DART AEROSPACE	LTD	Work Order:	22405
Description: Beam Asse	embly	Part Number:	D3173-041
	£ ,		
Dwg: D3173 Rev. B	4	Qty:	1
			Page 1 of 1

DESIG	m Cp	DRAWN BY	DART AEROSPACE LTD HAWKESBURY, ONTARIO, CANADA	
CHECK	(ED,	APPROVED	DRAWING NO. D3173 SHEFT	REV. B
DATE	114	- गम	TITLE SHEET	1 OF 3 SCALE
03.0	1.07		BEAM ASSEMBLY	NTS
Α		02.12.03	NEW ISSUE	
В		03.01.07	REMOVE PIP PINS

D3173-041 BEAM ASSEMBLY

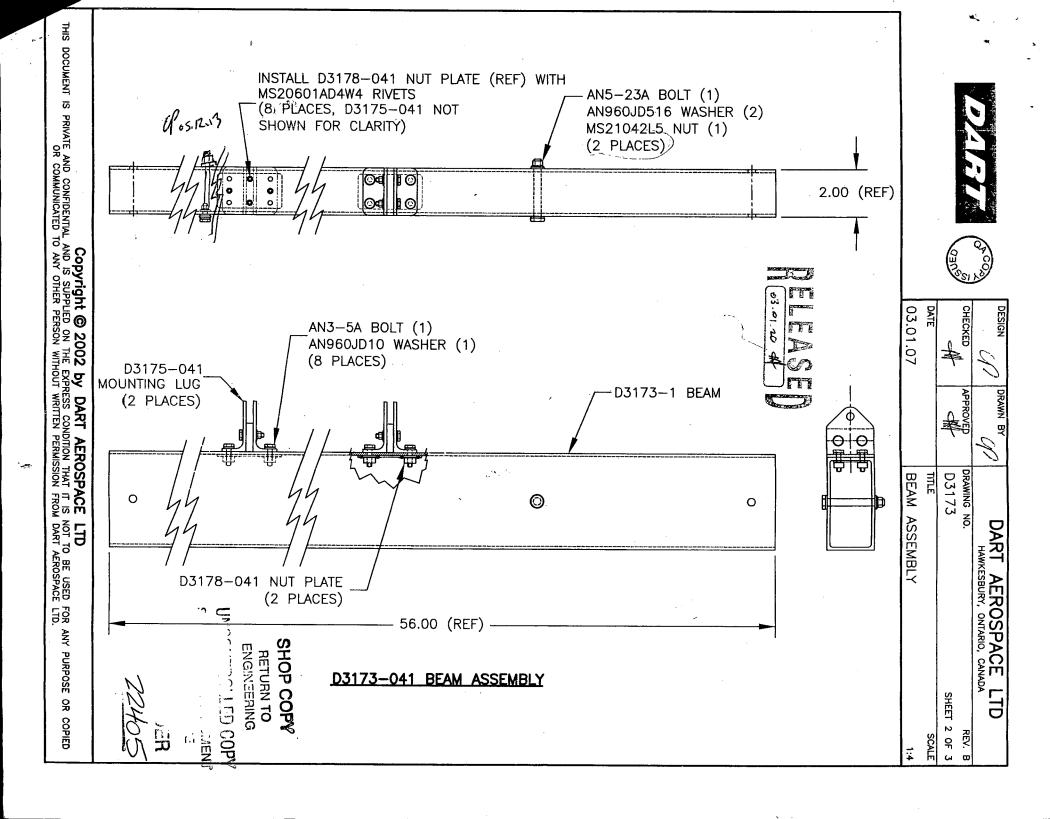
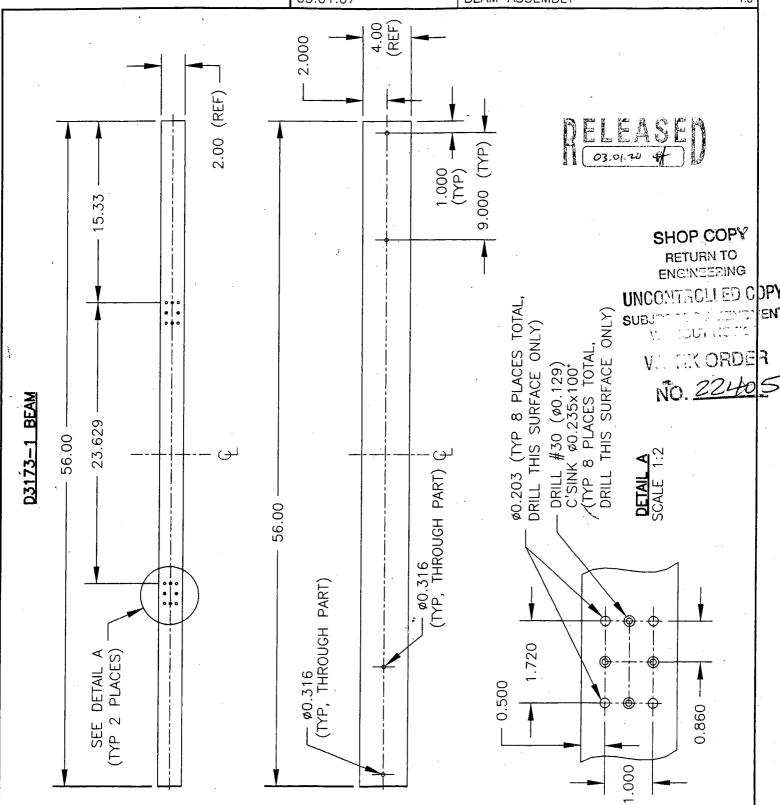
W/O:		WORK ORDER CHANGES						
DATE STEP		PROCEDURE CHÂNGE	Ву	Date	Qty	Approval Mfg / Design Mgr	Approval QC Inspector	
65-66-B	. 7	liple change too buy 03173 for sicle holes. (missing one hole that passes right through. Dermanent Change				65.12.13 0 4 951 018	45-05:13	
es-01:13	70_	Dept Change - formount Change		,	6		To a superior

NCR:		WORK ORDER NON-CONFORMANCE (NCR)							
DATE STEP		Description of NC		Corrective Action Section B		Verification	Approval	Approval	
		Section A	Initial Action Description Sign & Design Mgr Date		Section C	Design Mgr	QC Inspector		
US.66.24	3	Holes drilled on side face of boom instead of top face.	P	Drill holes in correct location, Fill incorrect holes with weld and grind flush, Ensure sorface is smooth with nu pitting	05-09+	3 05/09/13	65.07.173 P# 951642	05-09.12

Holes were accidently drilled on the side face, full size, both attachment locations, centered on the neutral axis. They were filled with weld. I noticed one of the welds has a small cavity (beam2.jpg), I would need them to fix that.

Is this acceptable?

This is an acceptable repair for this part.
